Amendments to the Drawings:

REMARKS/ARGUMENTS

100
FIG. 1 (Prior Art)

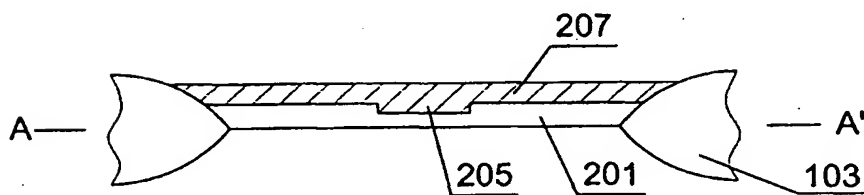
Examiner objected to Figures 1-3 and stated that these figures should be designated by a legend such as "Prior Art." Figures 1-3 have now been amended to include legends. Figures 1 and 6 were objected to as failing to comply with 37 CFR 1.84(p)(5) because they include reference characters not mentioned in the description. Applicants have corrected the specification to include the omitted reference characters. Also, Examiner objected to Figure 7 as being so dark that the features shown therein could not be ascertained. Accordingly, Applicants have filed a replacement sheet for Figure 7. Applicants respectfully request Examiner reconsider and withdraw his objections to Figures 1-3 and 7 in light of the previously described amendments.

The attached sheets of drawings include changes to Figures 1-3 and 7. These sheets, which include Figures 1-3 and 7 replace the original sheets including Figures 1-3 and 7.
